**DOCUMENT 00 90 00
ADDENDUM**

ADDENDUM NO. [3] Date: March 22, 2018

**RE: EAU CLAIRE AREA SCHOOL DISTRICT
McKINLEY CHARTER SCHOOL
1266 McKINLEY RD
EAU CLAIRE, WISCONSIN 54701
HSR PROJECT NO. 17057**

**FROM: HSR Associates, Inc
100 Milwaukee Street
La Crosse, WI 54603
(608) 784-1830**

C102R

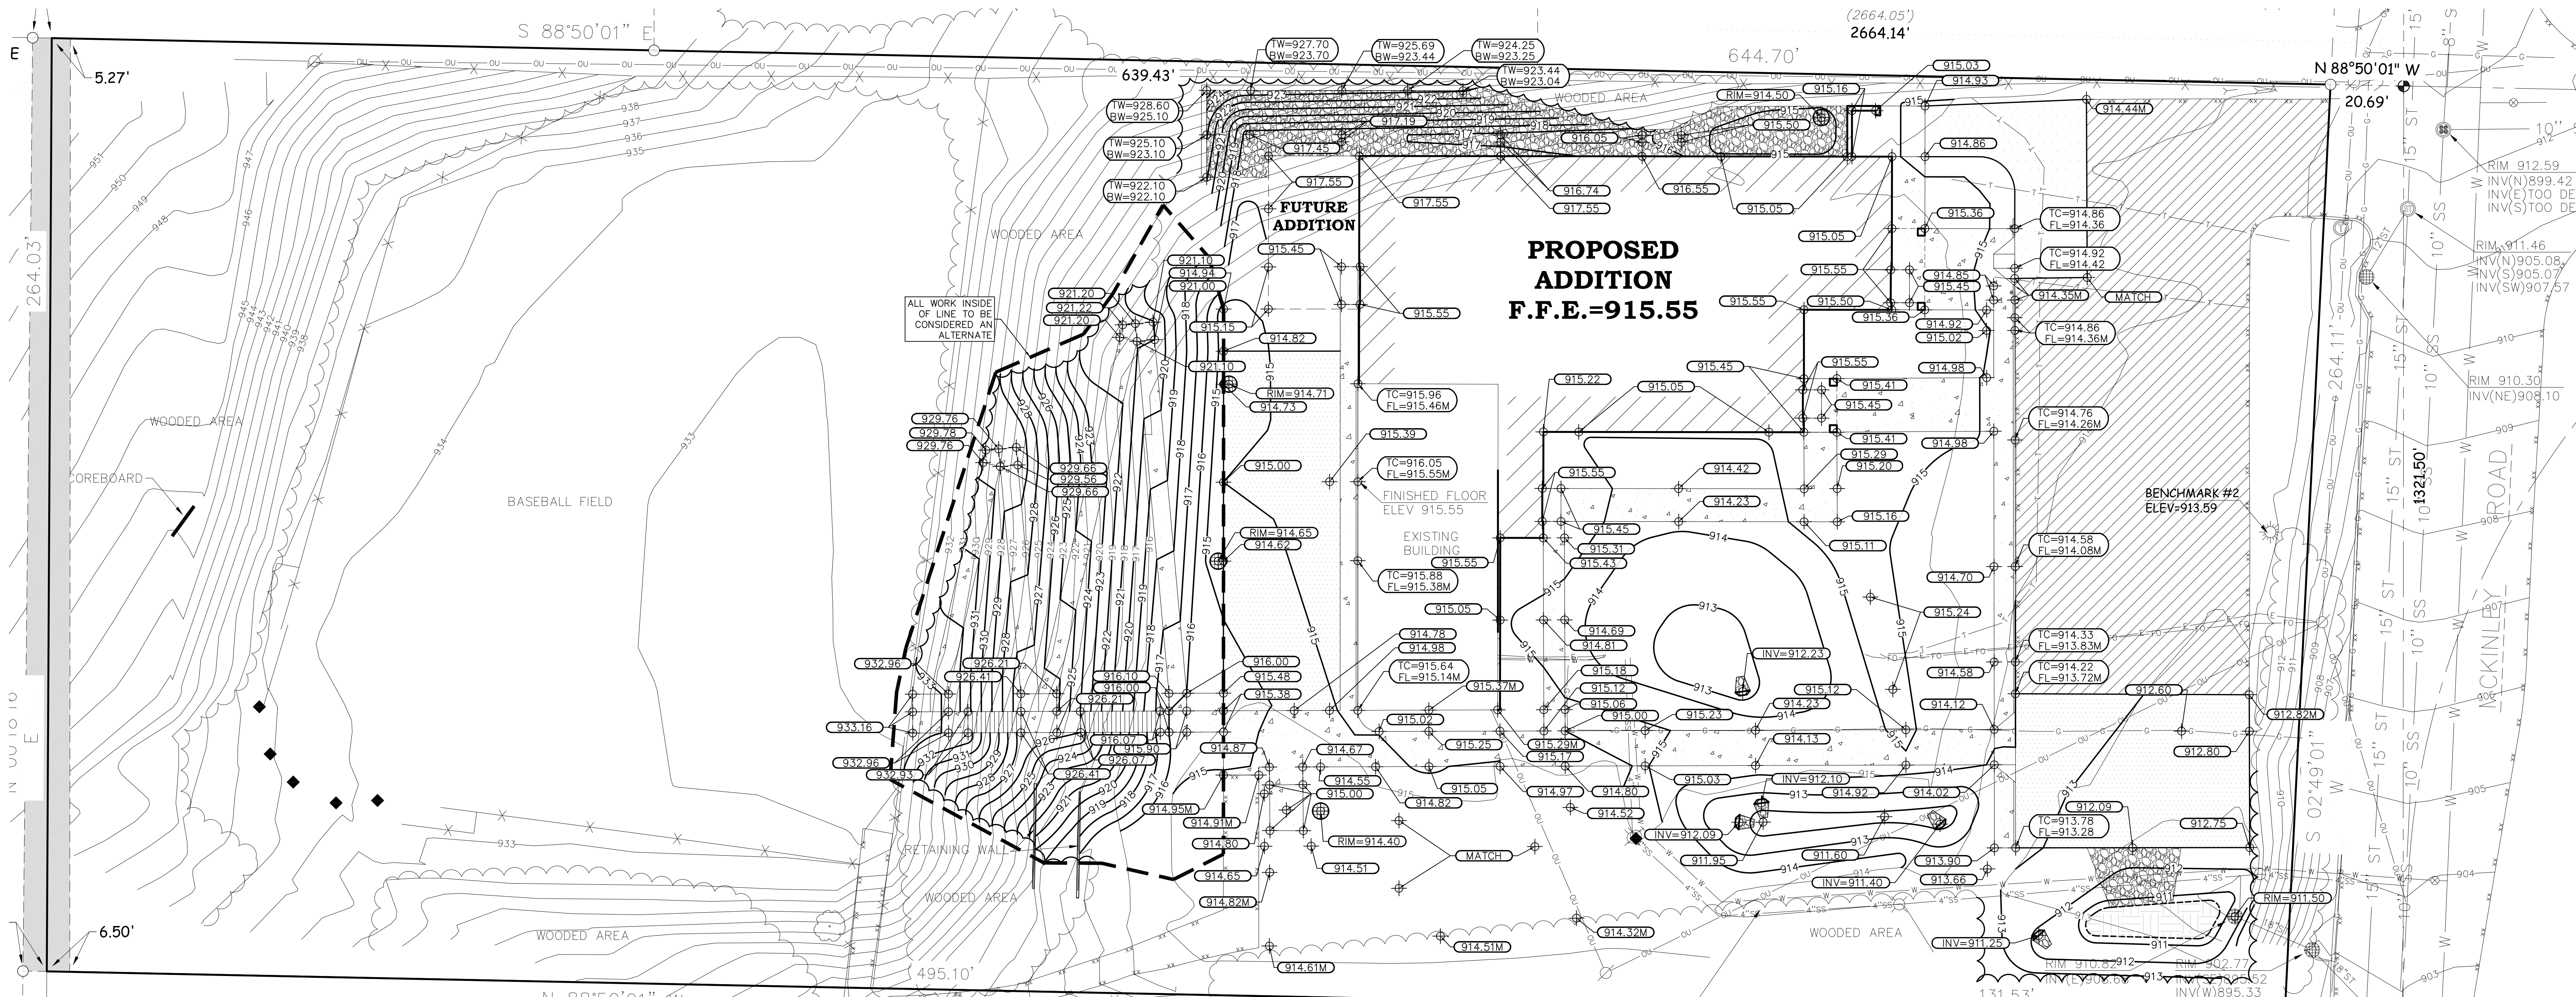
1. Sheet C101 LAYOUT PLAN
 - a. Add detail reference 5C102 to Keynote 6.
2. Sheet C102R GRADING PLAN 30 x 42 attached hereto
 - a. Detail 5C102 added for retaining wall at area northeast of building.
